Critical Review of the Root Cause Investigation of Crystal River Delamination

DECEMBER 2019

VICTOR E. SAOUMA

Figure 11: Comparison of PII computer model predictions for radial displacement from pass 4 through pass 11 at various elevations to the laser scanning data (ADAMS Accession No. ML 102861026, 2010)

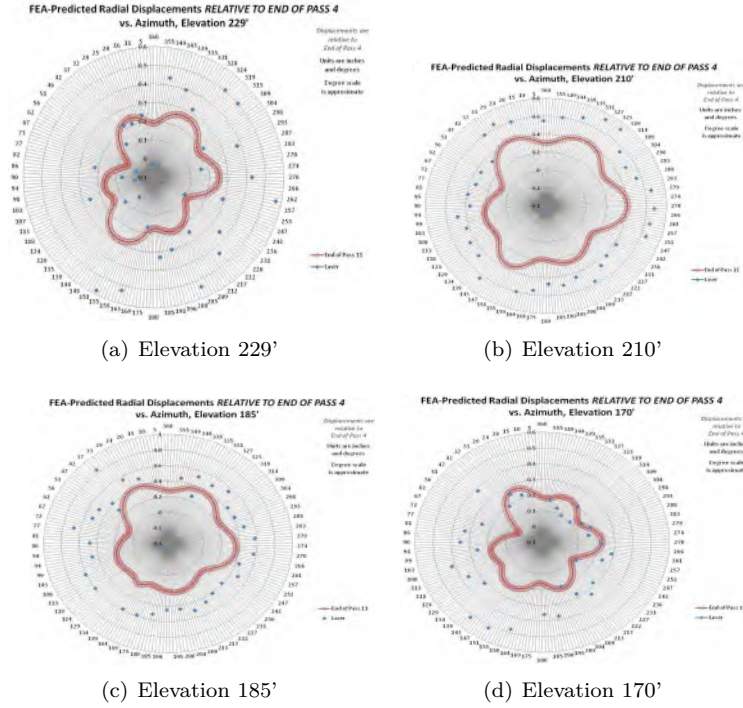
“Benchmarking” of the code results are inconclusive at best. SIT (in theory) should not have induced any nonlinearity (cracking or otherwise), hence excellent correlation between measurements and computations should be expected. Indeed adequate correlation is reported, however this does not necessarily validate the code for nonlinear analyses.

Validation with the 2010 detensioning is inconclusive as there are too many variations in laser readings, and errors bars are not included for either of the two reported values (experimental or numerical). The term “Benchmarking” is unfortunate, a more traditional term would have been “Validation” or possibly “Calibration” (as it is reported later that elastic properties have been modified to yield adequate correlation between numerical findings and field observations).

Figure 12: Group 1 Finite element Analyses (ADAMS Accession No. ML 102861026, 2010)

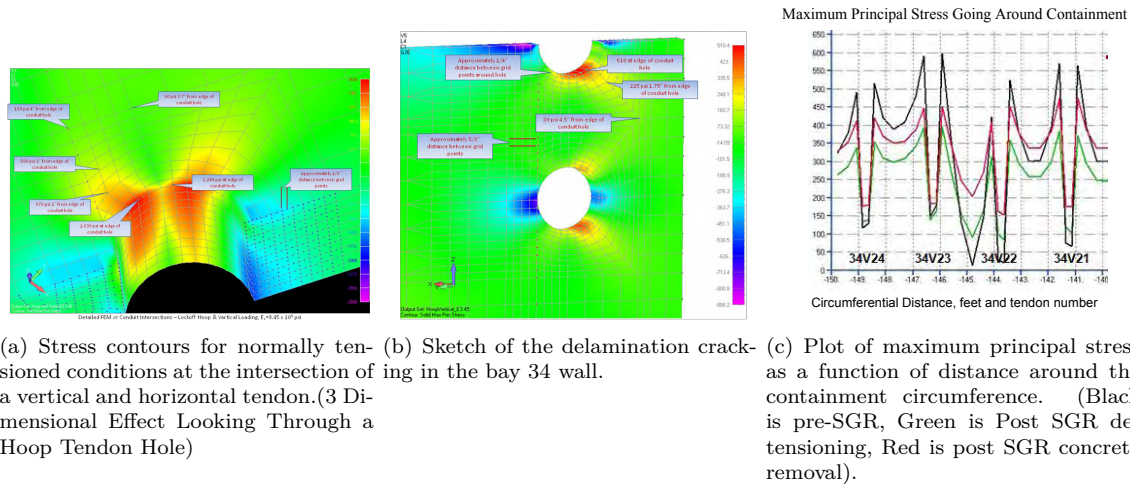
The report addresses the finite element model used for group 1. We find it confusing. The authors start by professing not to use NASTRAN to quantify fracture, and as such fracture parameters are not applicable. Yet ever since the pioneering work of Hillerborg, Mod  er, and Petersson (1976) any modern investigation of concrete fracture would have to use fracture mechanics. The website of the International Association

A particularly troublesome approach taken by the authors is the liberty with which material properties are at times modified to match intended results. In the table, E_0 is equal to 3.45×10^6 in the Abaqus analyses, and 4.29 in the NATRAN analyses, Table 2.

Figure 19: Models

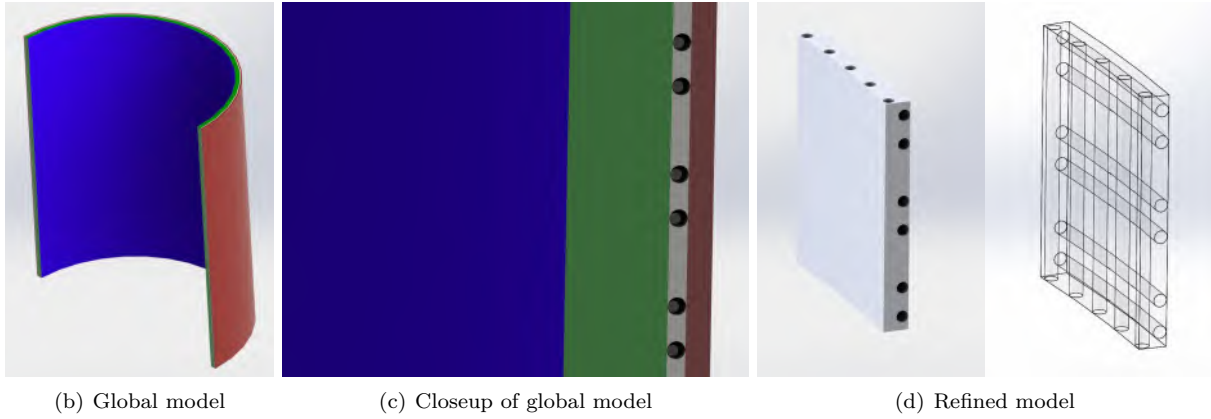
Point loads in the Sleeves Tendon loads in the sleeves were applied as line loads. This induced a stress singularity which may have been interpreted as cracking. This is clearly visible in both Fig. 12(a) and 18. Those are “distractions” from the actual stress field which may have caused cracking/delamination. Modeling the stiffness of the sleeve is very unlikely to have sufficiently smoothed or distributed the point load into a traction wide enough to avoid stress singularity.

From Global to Detailed A two tier analysis for complex structures is not unusual (this is commonly referred as “substructuring” in finite element parlance). it is not clear how the boundary conditions are transferred from the global to the detailed model, specially that the report mentions a so-called “driven region” Fig. 8(g) Finally, the panel (detailed model) should be subjected to high vertical compressive forces caused not only by the post-tensioning but also the self weight of the structure. There is no indication that this was accounted for.

1. There is no indication in the report on how the various constituents of the global or detailed models are connected. Is there a full connection, are nodes master-slaved, or are they assumed to act independently as a parallel system (as opposed to a single one)?
2. In the absence of such information, and in view of the observed “delamination” (Fig. 14(e), 14(f) and 8), indications are these constituents were not all tied together, and as such, of course a “delamination” will be observed. As discussed in the next section, the analyst should have tied the damage material region, Fig. 8(f) to the adjacent ones by joint/interface zero-thickness elements commonly found in most finite element codes. These can range from the simplest ones (Goodman, R.E. and Taylor, R.C. and Brekke, T.C., 1968) to the more advanced fracture mechanics based one (Cervenka, Chandra, and Saouma, 1998).

Keeping in mind that there is a one way coupling (that is from global to the detailed model) and that the simplified linear elastic global model was able to capture delamination (Fig. 14(e), 14(f)) why was there a need to perform the detailed analysis and then capture the delamination in Fig. 8?

the delamination in the global model is captured as a separation of nodes (implying that no interface elements were used), and in the detailed model, is conjunctured that it occurred in light of the damage zone showed through the continuum elements in Fig. 8.
